# Access Compliance Report

## Public Rights-of-Way

### (Curb Ramps)

Intersection ID: 2544	Main Street: HARTFIELD_DOWNS_DR	Cross Street: HIGHLAND_CREEK_PY	Location: SW
ADA ID: F40C86383956	Ramp Type: Perp	Initial Pass/Fail: Fail	Overall Compliance: No
Severity Score: 10			
Codes/Mitigation Info/Possible Solution		Field Measurements/Component Compliance

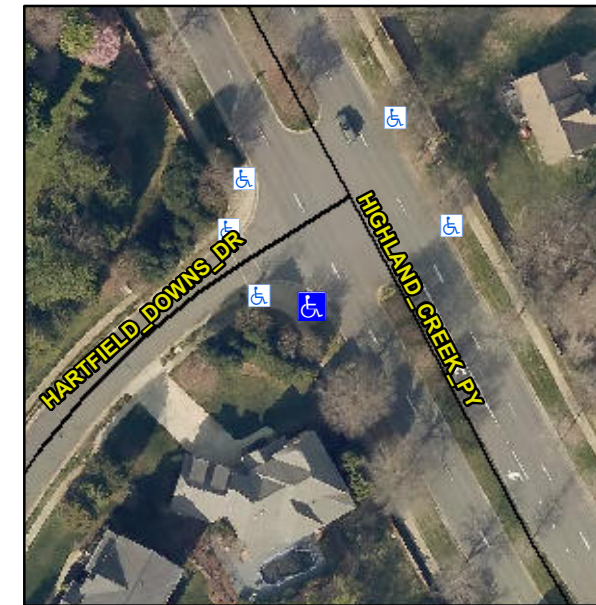
**R304.5.1, R304.5.3**

Compliance	Description	Data	Compliance	Description	Data
N/A	Ramp Length (in)	132.0	Yes	Ramp Slope (%)	7.9
No	Ramp Width (in)	38.0	No	Ramp XSlope (%)	3.7
N/A	Flare Type LT	N/A	N/A	Flare Type RT	N/A
N/A	Flare Slope LT (%)	N/A	N/A	Flare Slope RT (%)	N/A
N/A	Flare Traversable LT?	N/A	N/A	Flare Traversable RT?	N/A
N/A	Landing Length (in)	N/A	N/A	DWS Provided?	N/A
N/A	Landing Width (in)	N/A	N/A	DWS Contrast?	N/A
N/A	Landing Slope (%)	N/A	N/A	DWS Length (in)	N/A
N/A	Landing X Slope (%)	N/A	N/A	DWS Full Width?	N/A
N/A	Landing Curb? (Y/N)	N/A	N/A	DWS Offset (in)	N/A
N/A	Shared Landing?	N/A			
N/A	Gutter Ponding?	N/A	N/A	Gutter Slope (%)	N/A
N/A	Gutter Lip Ht (in)	N/A	N/A	Gutter X Slope (%)	N/A
N/A	Painted X Walk1?	No	N/A	Painted X Walk2?	N/A
	X Walk 1 Direction	To E		X Walk 2 Direction	N/A
N/A	X Walk 1 Width (in)	N/A	N/A	X Walk 2 Width (in)	N/A
	X Walk 1 Slope (%)	0.1		X Walk 2 Slope (%)	N/A
	X Walk 1 X Slope (%)	3.3		X Walk 2 X Slope (%)	N/A

N/A	Ramp inside XWalk1?	N/A	N/A	Ramp inside XWalk2?	N/A
	Road Slope (%)	N/A	N/A	Clear Space?	N/A
	Road X Slope (%)	N/A	N/A	Clear Space to XWalk (in)	N/A
N/A	Any Obstructions?	N/A	N/A	Storm Grate/Utility Hazard?	N/A
	Obstruction Type			Storm Grate/Utility Type	
		N/A			N/A
			Yes	Surface Condition? (G/P)	Good

**Remove & Replace Entire Ramp.**
